Appendix I of RNTPC  
Paper No. A/YL-NSW/289

APPLICATION FOR PERMISSION  
UNDER SECTION 16 OF  
THE TOWN PLANNING ORDINANCE  
(CAP.131)

3. Application Site 申請地點	
(a) Full address / location / demarcation district and lot number (if applicable) 詳細地址/地點/丈量約份及地段號碼(如適用)	D.D.104 Lot 3614 RP, Pok Wai, Yuen Long, N.T.

Proposed Temporary Shop & Service  
(Estate Agency) for periods of 5 years

Project: Planning Application at Lot 3614 RP in DD104		Scale:		Drawn By:		C22 Planning No. Zone		District		Title:	
										Plan 3

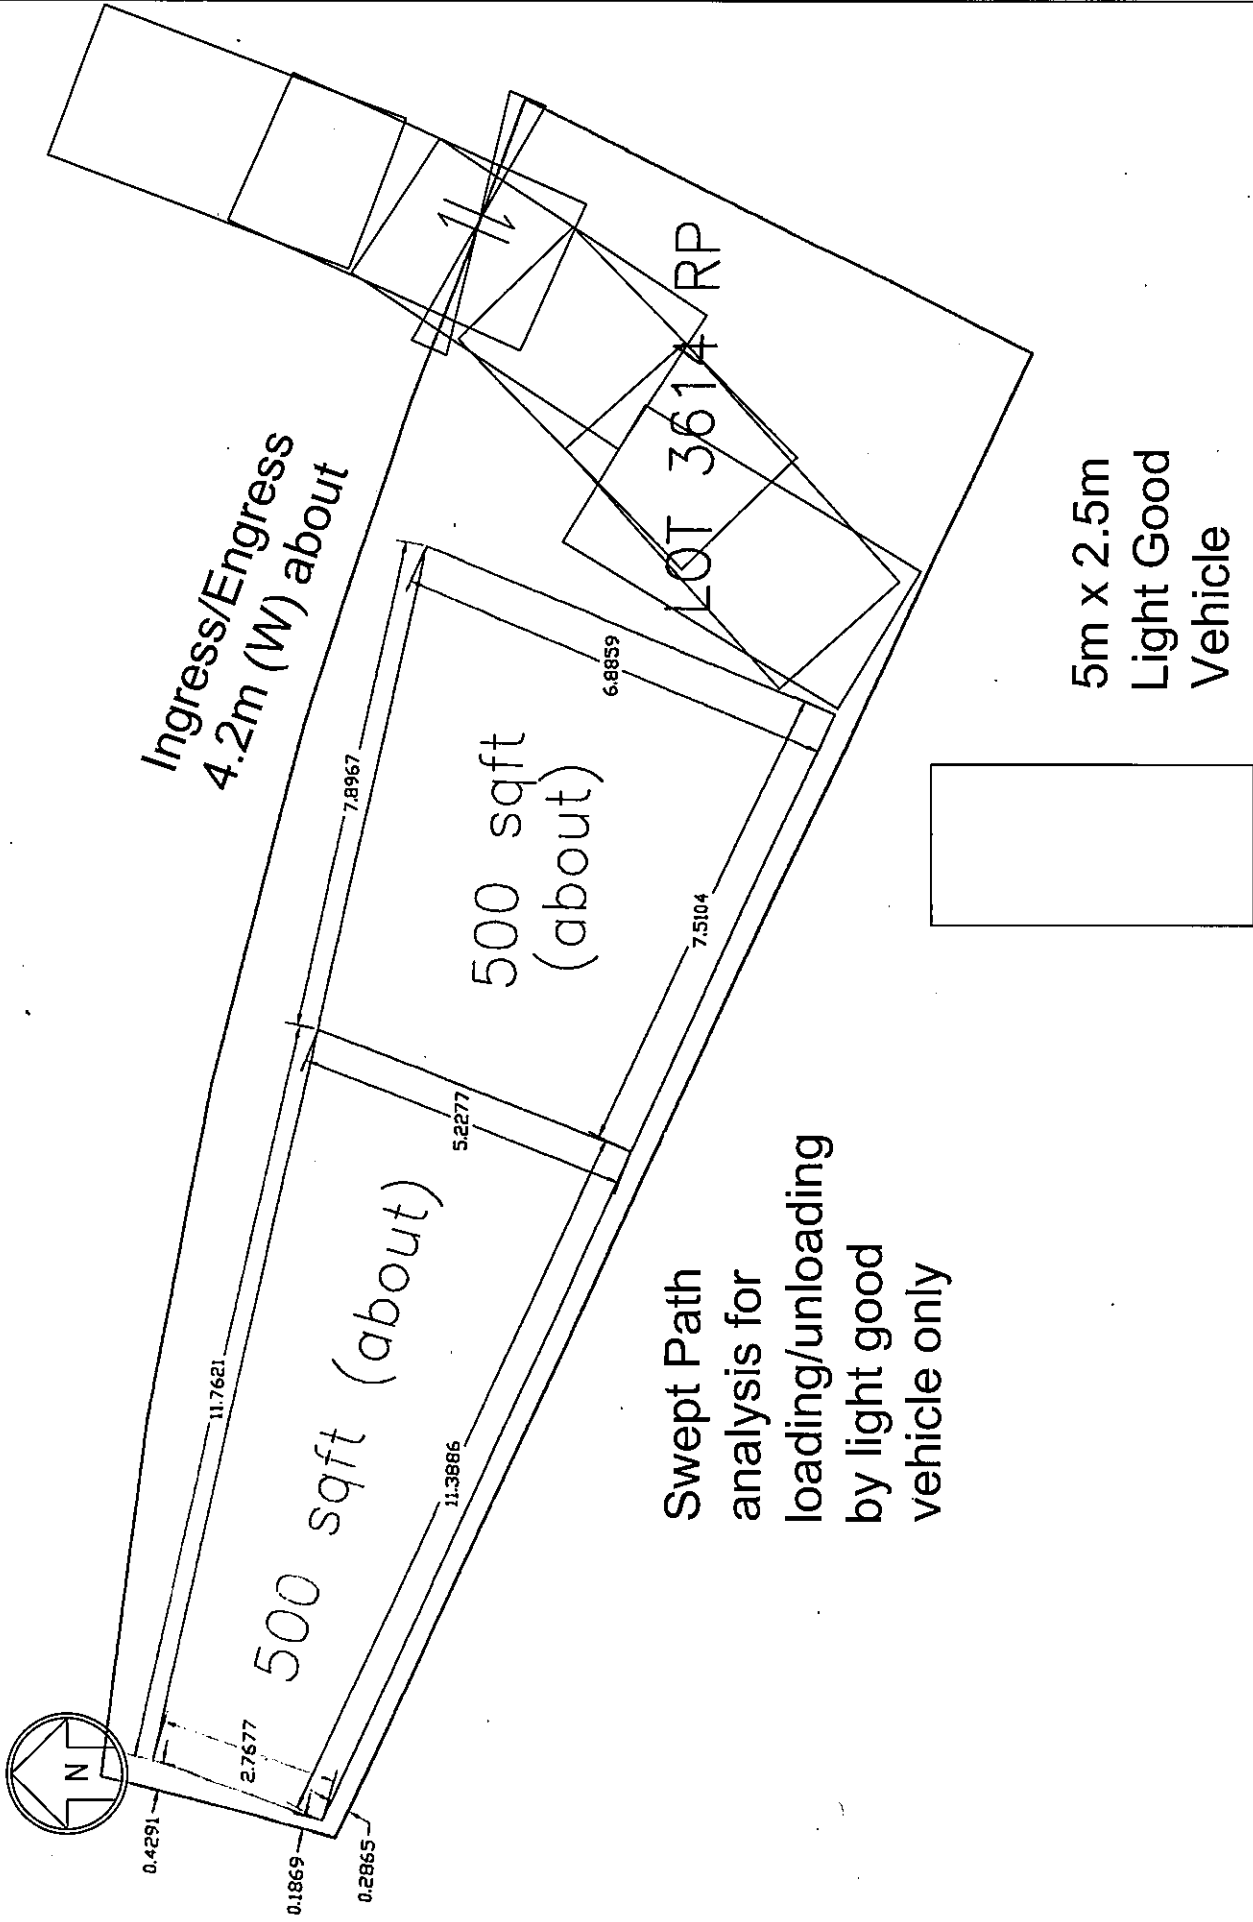
Comments	Reply Comment
a. The application should specify the type(s) of vehicle allowed for entering the subject site.	2.5m x 5m Light good vehicle is indicated on Plan 3.

b. The applicant should indicate the clear width(s) of the vehicular ingress/egress and demonstrate sufficient space for maneuvering of the types of vehicles allowed within the subject site.	4.2m width vehicular ingress/egress is indicated on the plan. Swept Path analysis is provided on Plan 3 in order to demonstrate sufficient space.

Project: Planning Application at Lot 3614 RP in DD104		Scale:		CZP: Planning No. Zone		District:		Title: Plan 4	
Drawn By:		CZP:		Planning No.		Zone		District:

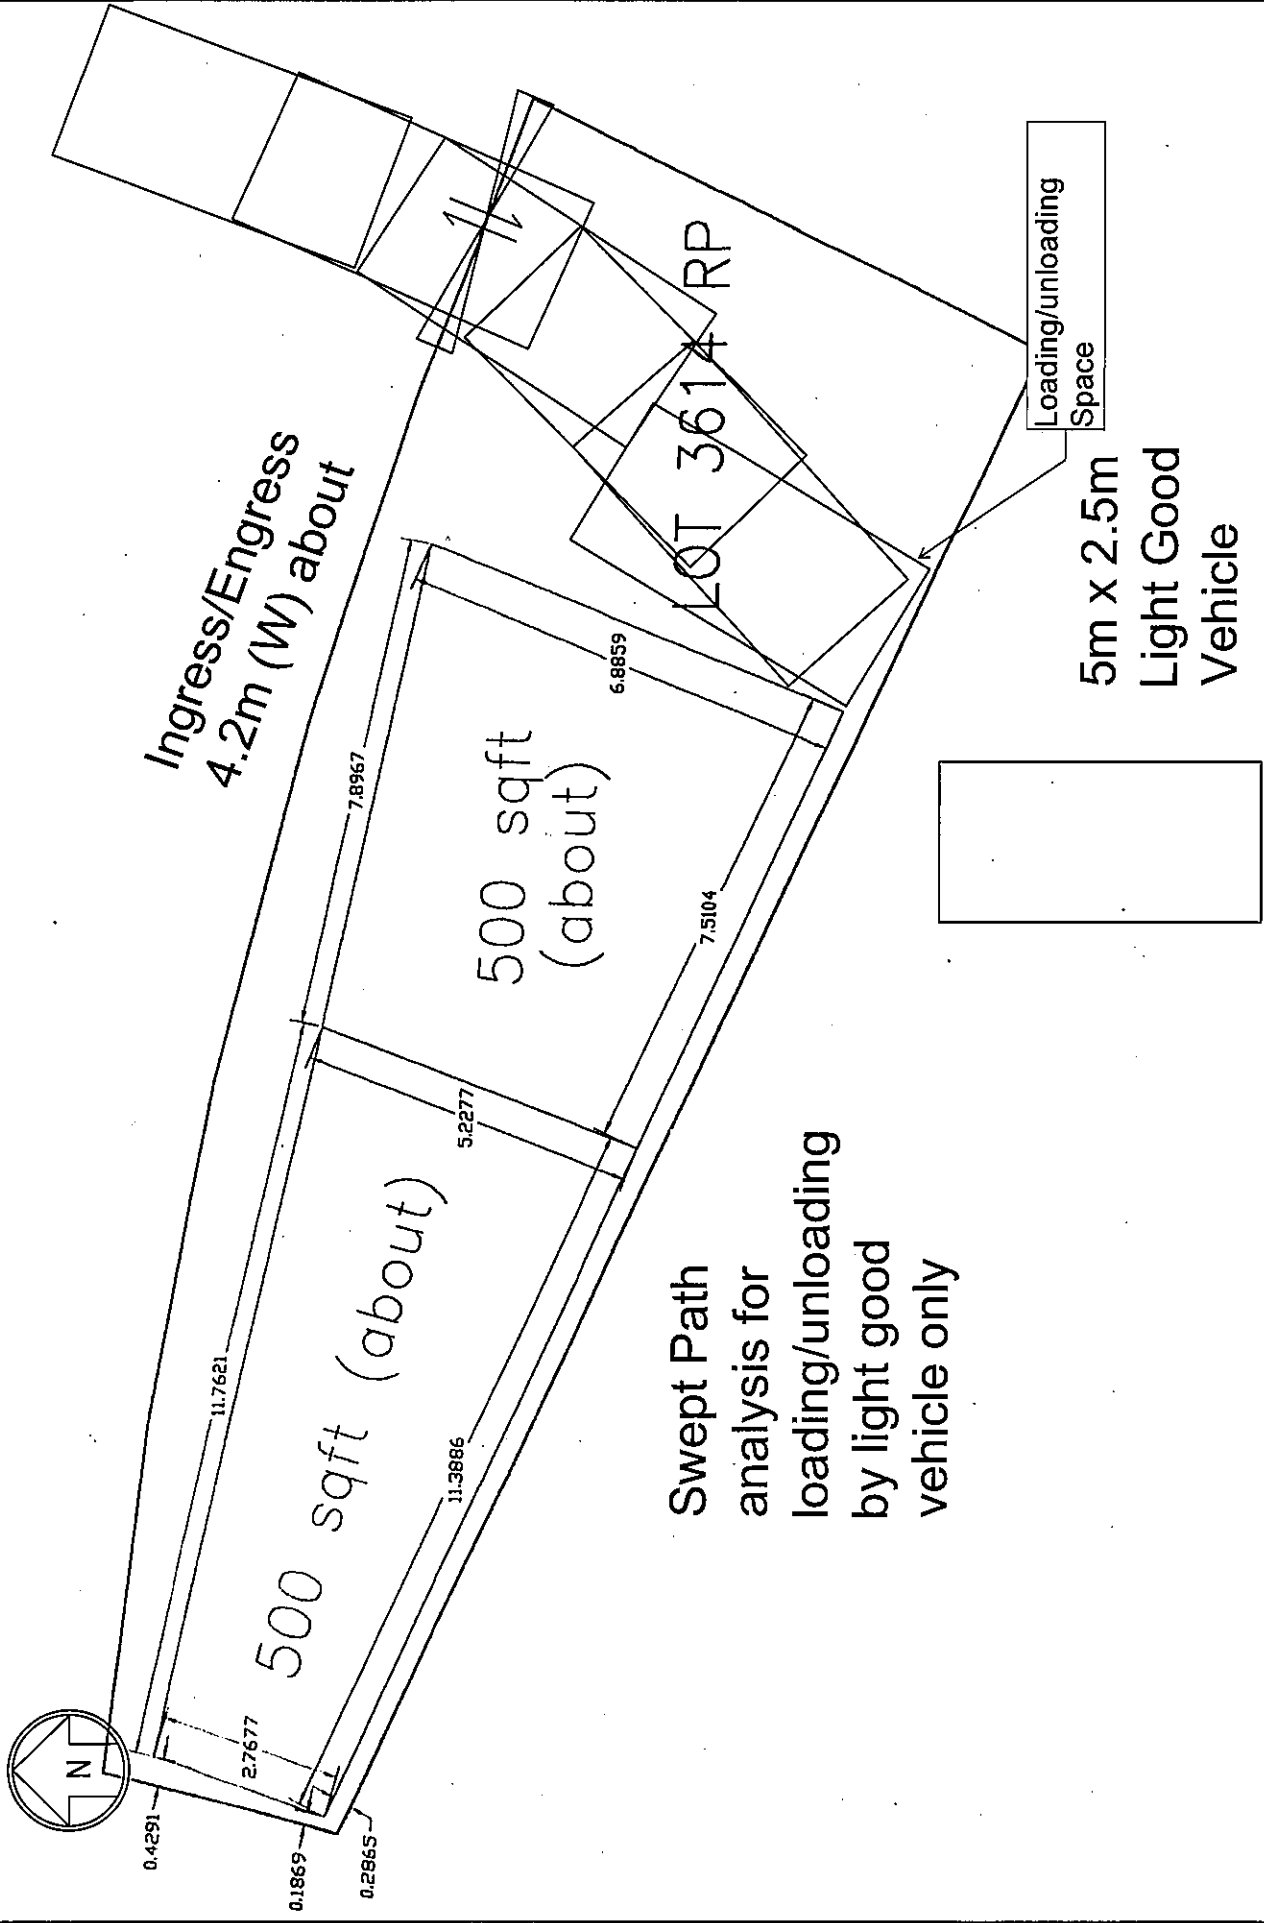
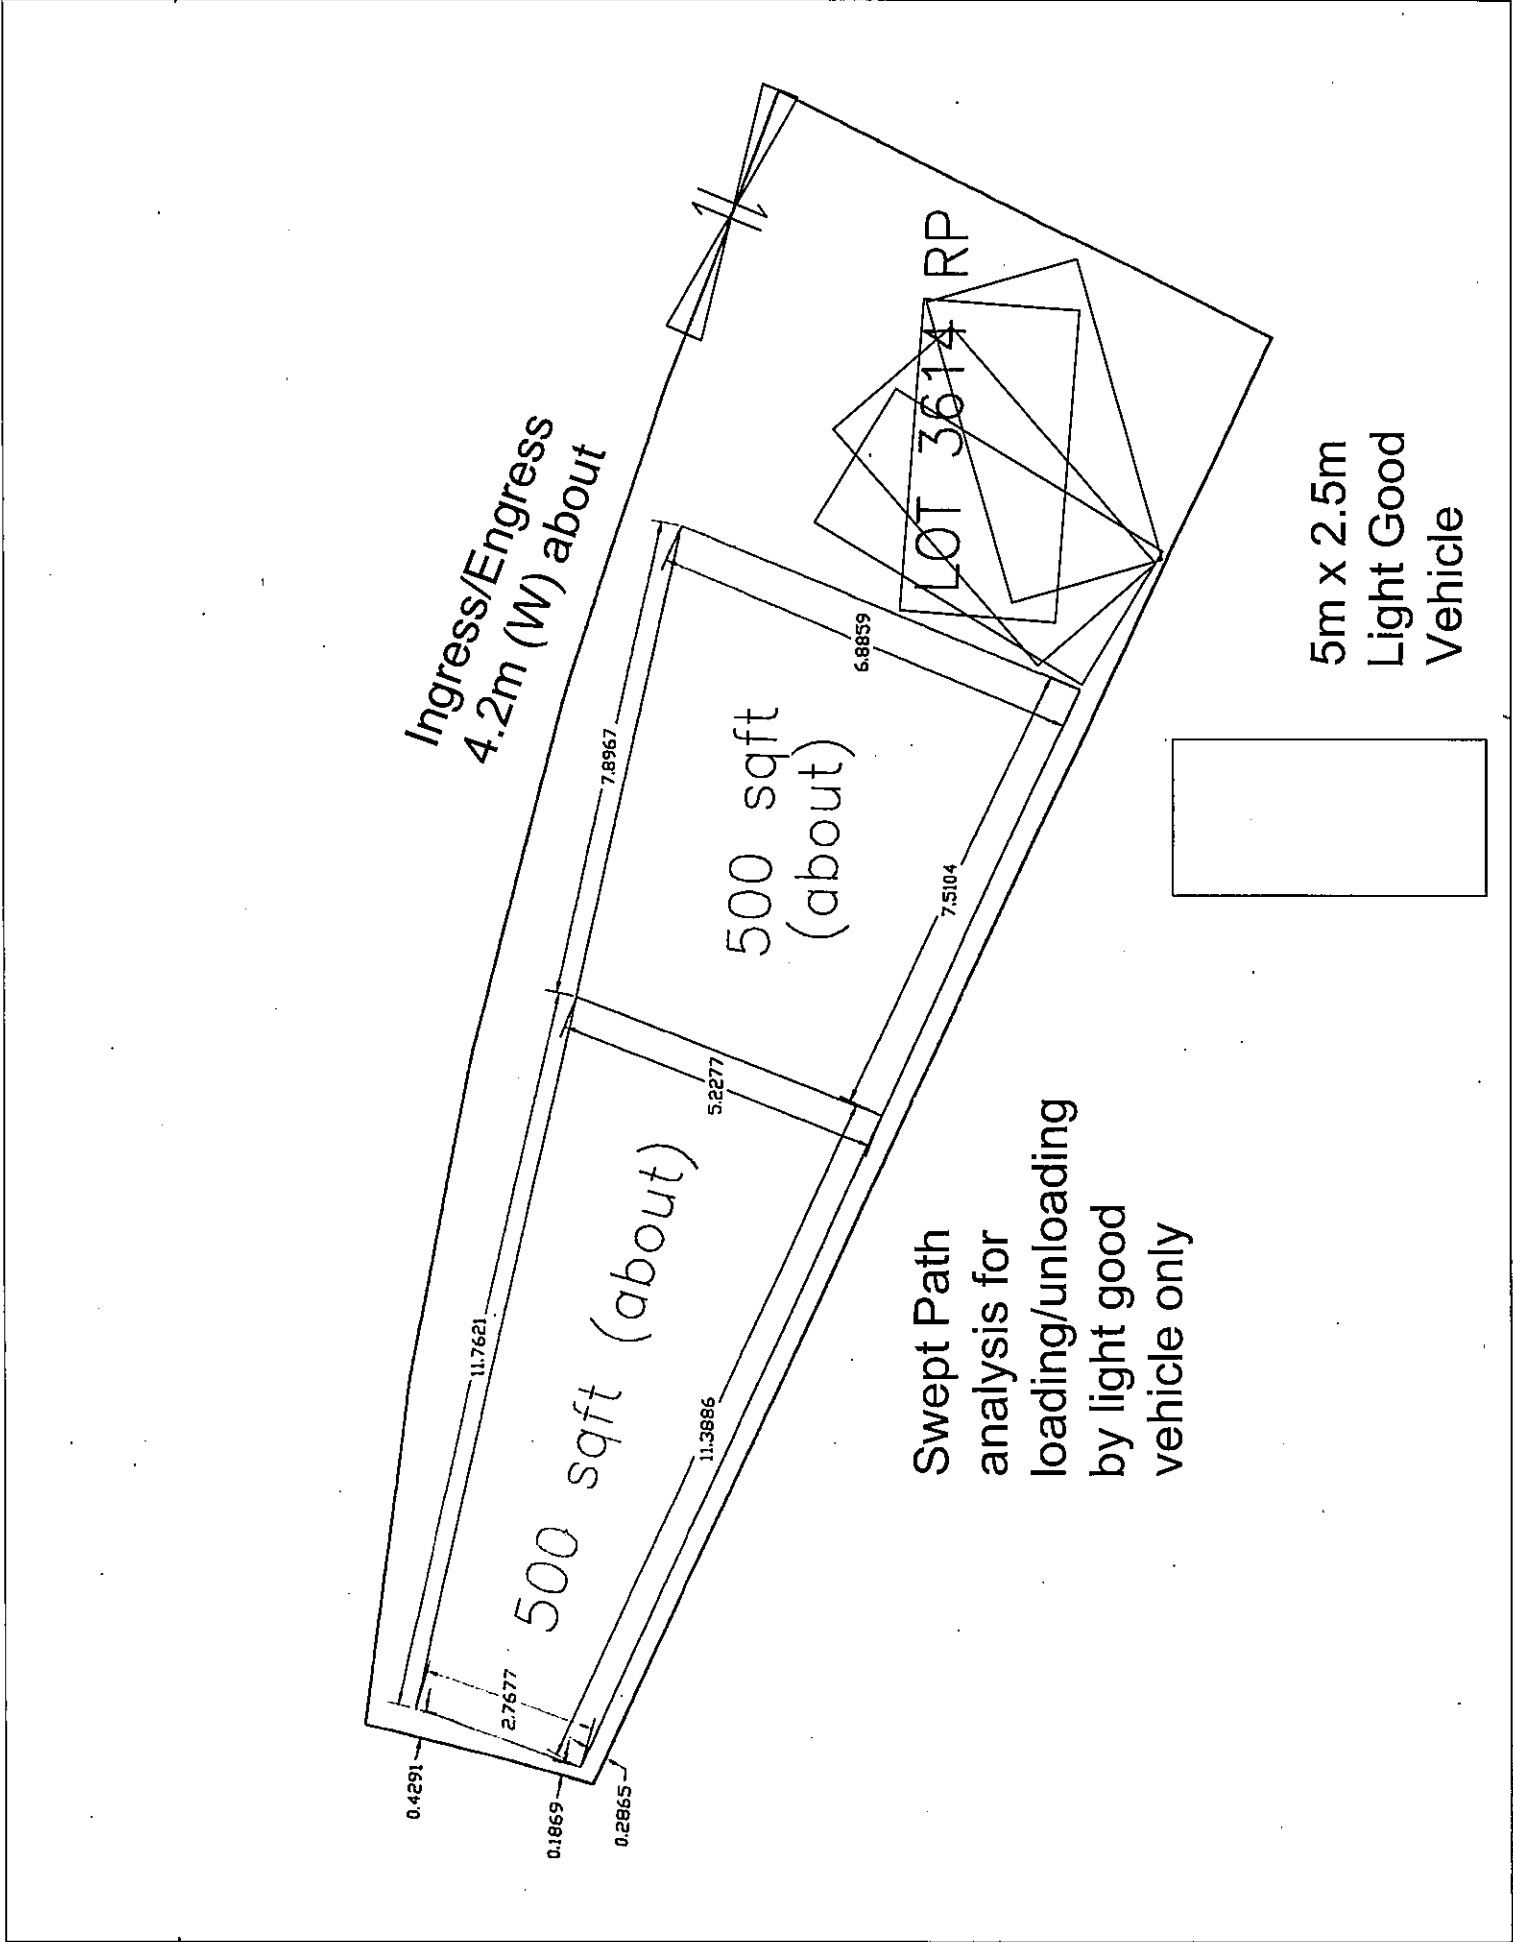
*The swept path analysis is shown in Plan 3 to Plan 6 to demonstrate that there is sufficient space for the type of vehicles to turn around within the subject site. The proposed location for loading/unloading space is indicated.*
